Evidence Book 13

Township of Guelph/Eramosa Noise Impact Review Document Book

Noise Impact Review Document Book Index

**Re: Peer Review, Acoustical Study
Hidden Quarry
Novus Project No. 12-0258**

Fig 2.4B Note: Applicant modelled groundwater contours do not coincide with water well static water levels adjusted to GRCA (2011) ground elevations.

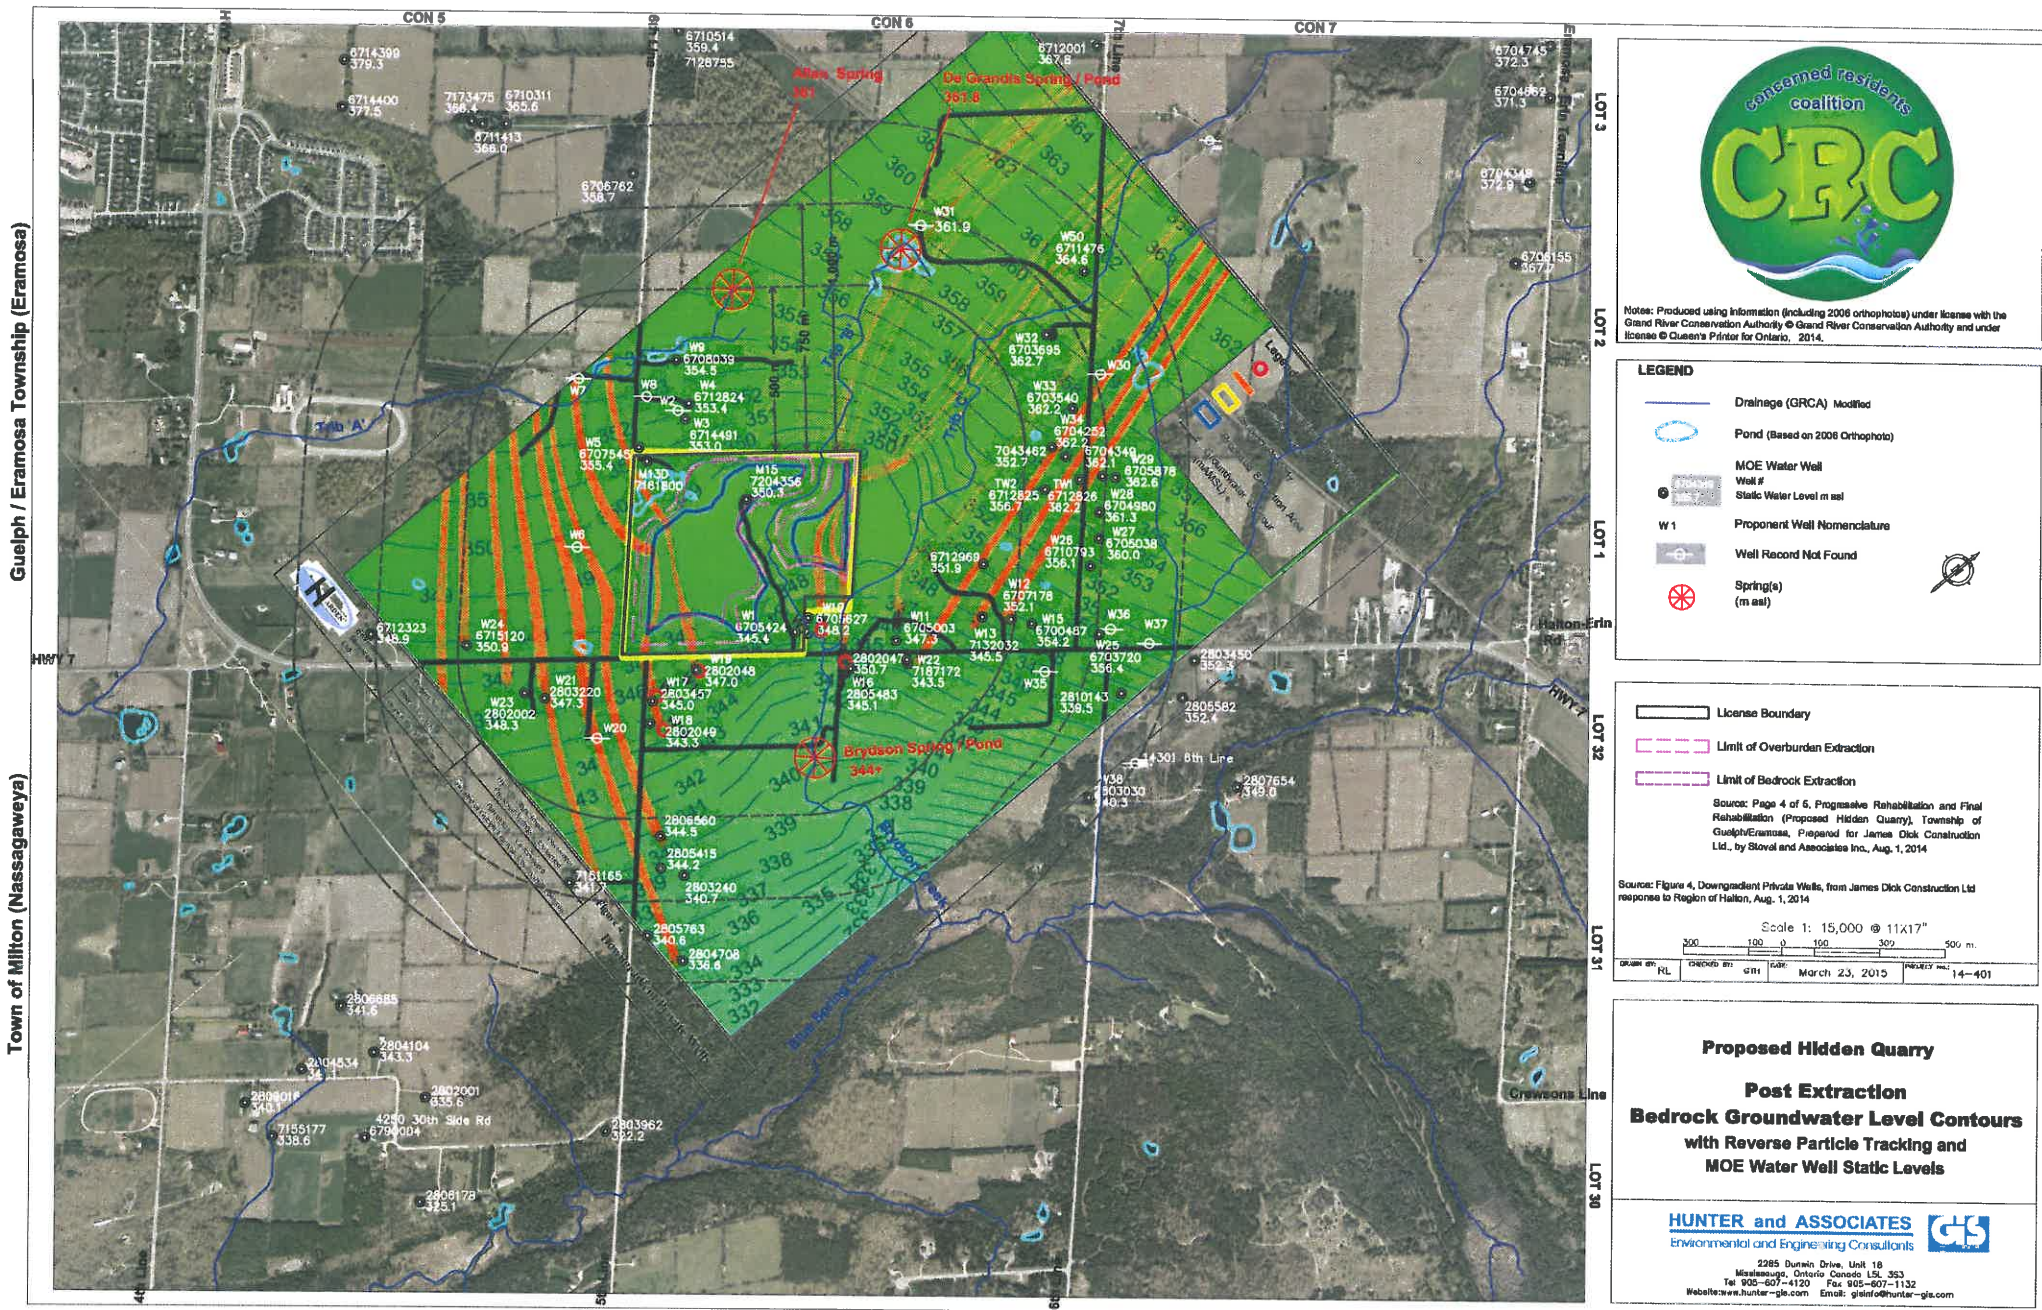
- Compared to the GRCA 2011 ground surface contours the Brydson Spring is at about 344 m al or about 4 m above the groundwater modelled contour. Similarly, the De Grandis Ponds are 3 to 4 m above the modelled contours. The static water level at W50 (MOE 67-11476 - 4978 7th Line Eramosa) bedrock well after correction to the GRCA 2011 ground elevation is 3.5 m above the Applicant's modelled contours (Fig 2.4B). **An explanation is required.**

Fig 2.4B The Applicant's (modelled) predicted groundwater contours (Fig 2.4A) are superimposed on the standard Hunter Hidden Quarry base map which contains domestic water wells with MOE #'s and static water levels elevations (m asl). It is noted that at W50 (added by Hunter) a known bedrock well at the front of the De Grandis farm, the Applicant's modelled bedrock water levels plot is about 3.5 m below the static water level when drilled and 3.7 m below the static water level at nearby W32 when completed.

Fig 3.1

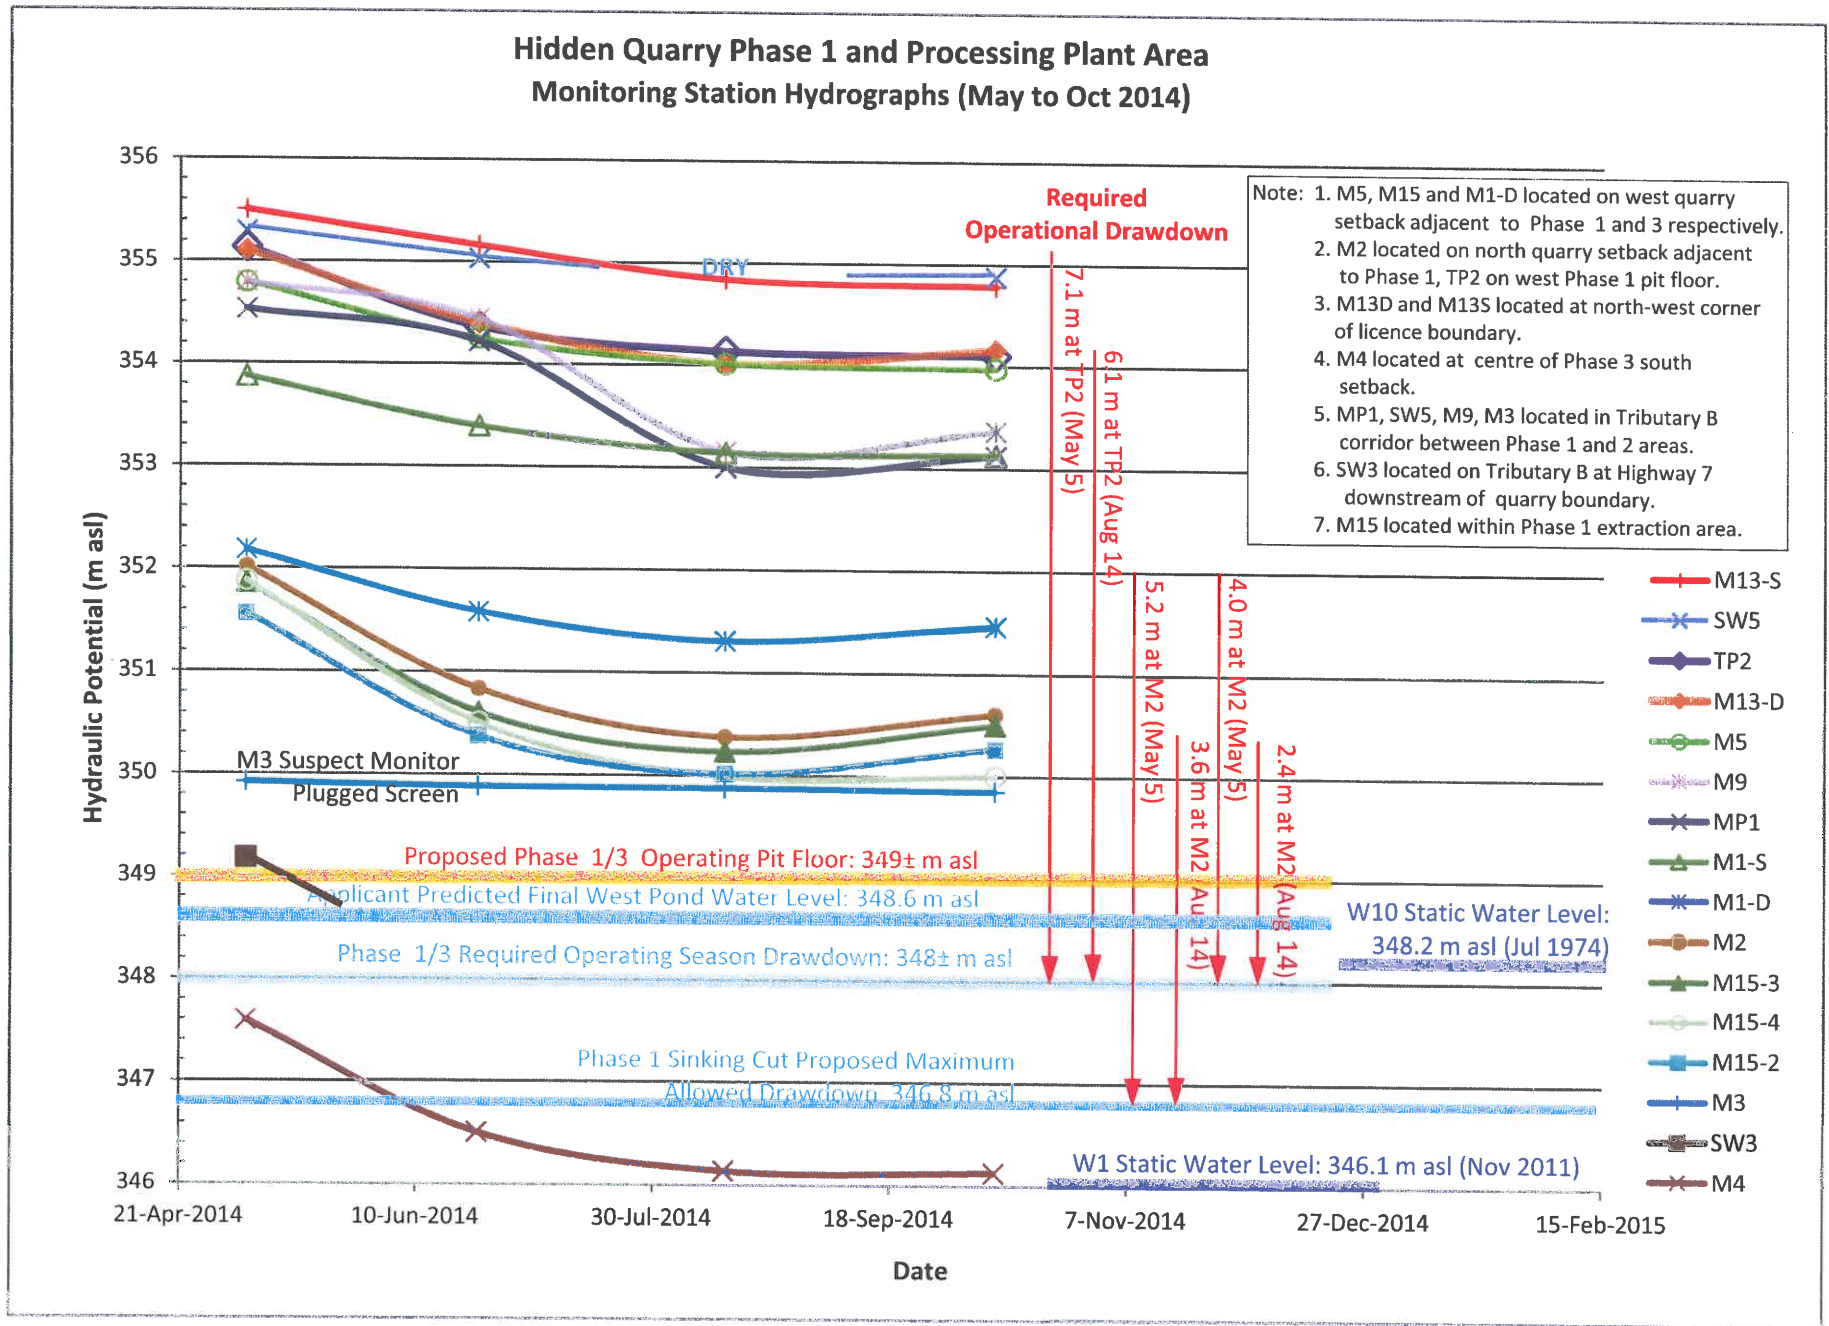
- Notwithstanding the Applicant Hydrogeologist's frequent statements that drawdowns will be gradually established, the Applicant's Operational Site Plan imposes maximum water table drawdowns in the north and west area of the quarry during overburden and weathered surface rock extraction prior to even initiating Phase 1 dolostone extraction (Fig 3.1).

Fig 3.1 The Applicant relied on its groundwater model to predict post-extraction final water levels. The Applicant did not have regard for the groundwater drawdowns required to actually operate the pit / quarry in accordance with its proposed Site Plans. This figure shows the actual operational drawdowns utilizing the Applicant's supplied May to October 2014 groundwater level monitoring as an analogue. Domestic well locations are shown on Fig 1.1 and the Applicant monitor locations on Fig 2.1. The actual drawdowns for the most part, especially during the spring season, significantly exceed the Applicant's post-extraction model estimates.

Fig 3.2

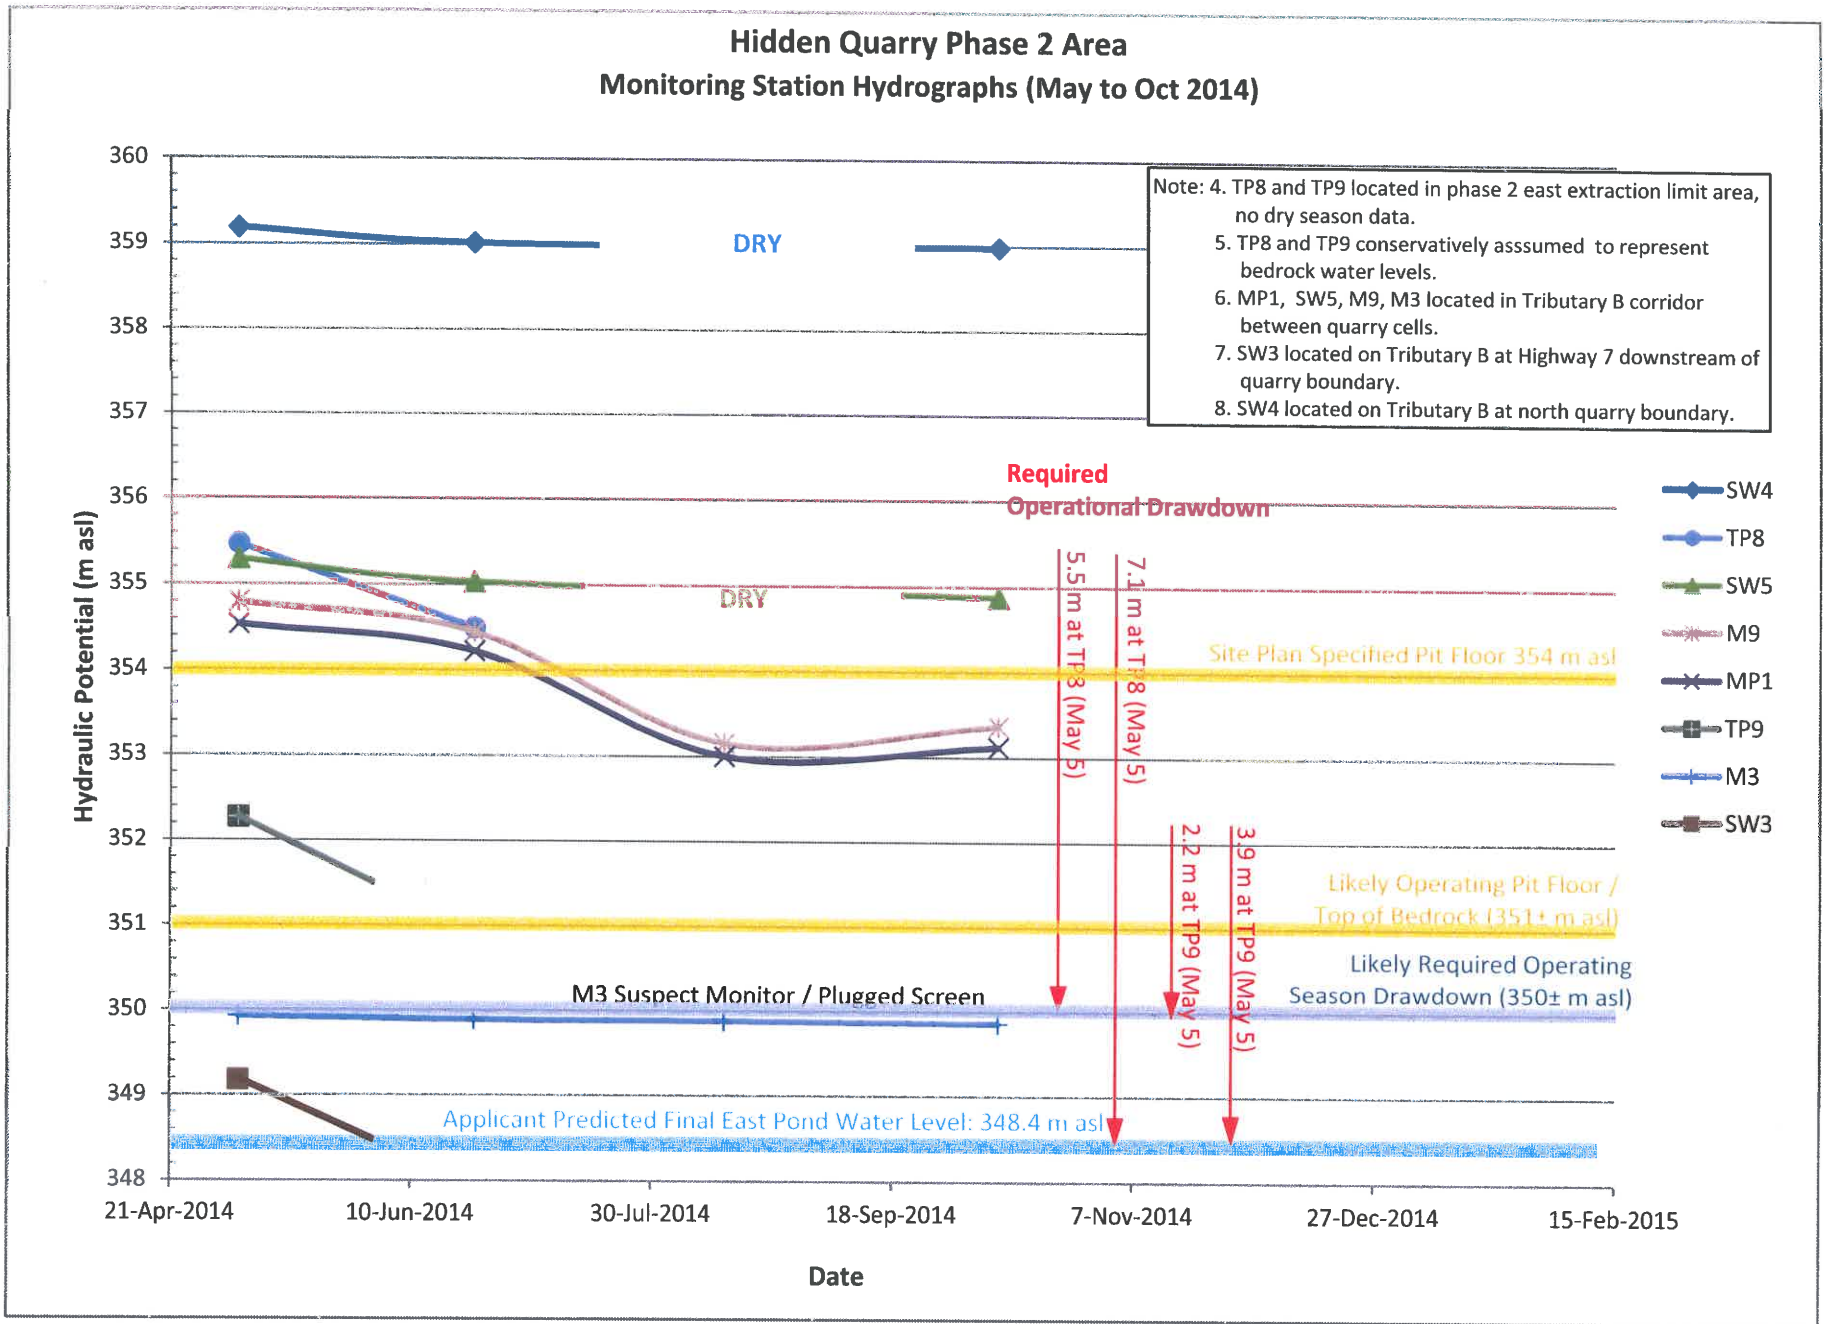
The proposed Operating Pit Floor (bottom of sand and gravel / top of dolostone) is a consistent 354 m asl in the Noise, Blasting Reports and on the March 19, 2015 proposed Site Plan version. **This Peer Review has assumed a Phase 2 pit floor at 351 m asl pit / quarry dry operational floor with a water table at 350 m asl (Fig 3.2) (see Sec 3.1 this report).**

- The Applicant has a deficiency of base of overburden / top of bedrock observations, no bedrock groundwater level monitoring and limited overburden water level monitoring in Phase 2 area. There is no technical support for the top of bedrock dry operating pit and quarry floor at 354 m asl as specified on the Site Plan (Fig 1.7).
- For my analysis I have assumed the Pit floor in the Phase 2 area at a more realistic 351 m asl. A lower operating dry staging platform offers greater acoustic protection for neighbours (Fig 3.2).

Fig 3.3

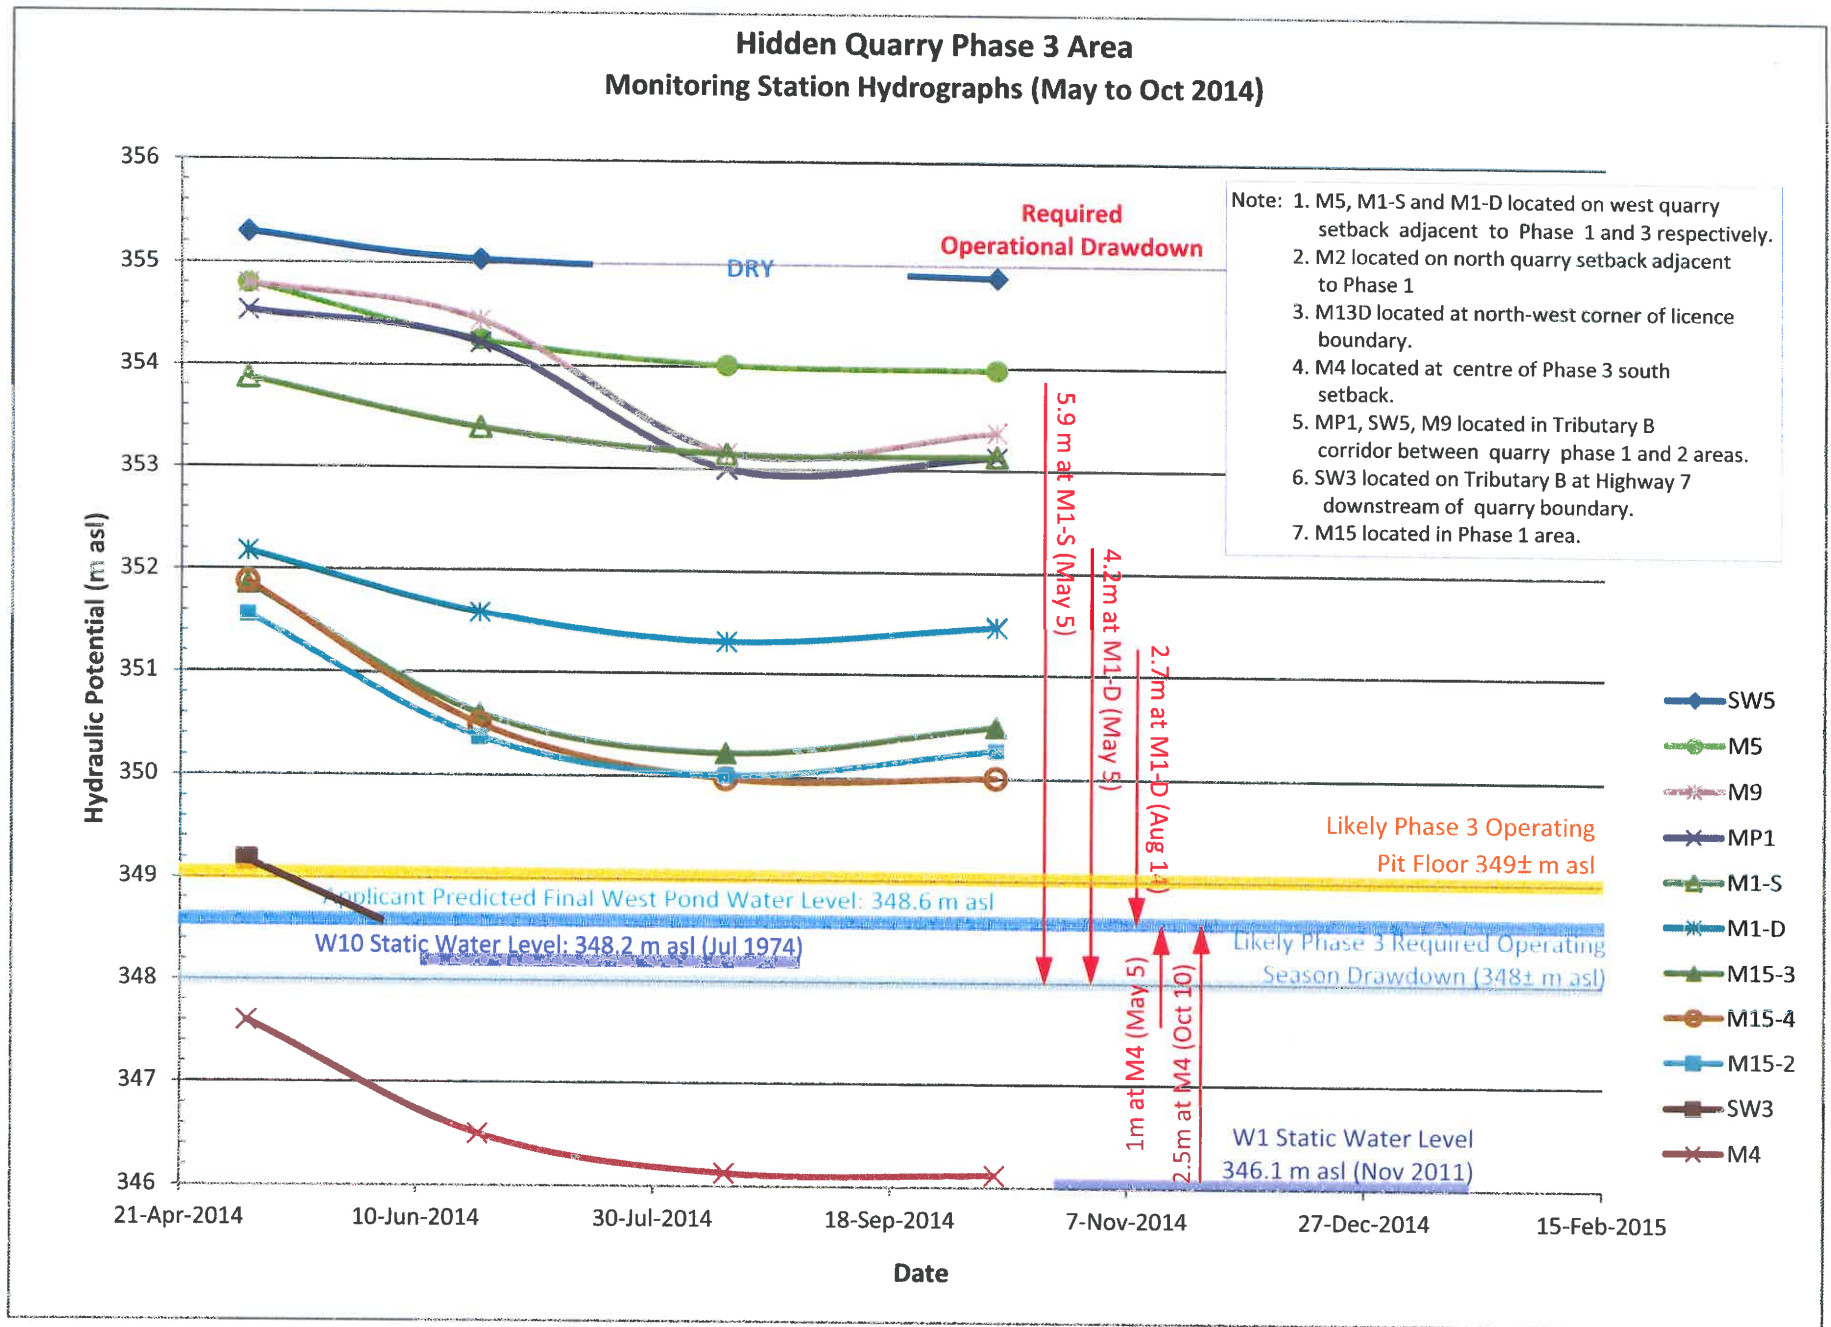
The Site Plan required operational drawdown in Phase 3 is to about 348 ± m asl slightly lower than the model predicted post extraction water level 348.6 m asl (Fig 3.3). **M4 static levels are less than 1 m below the required drawdown in the 2014 spring season and nearly 2 m below in the 2014 summer and fall seasons.**
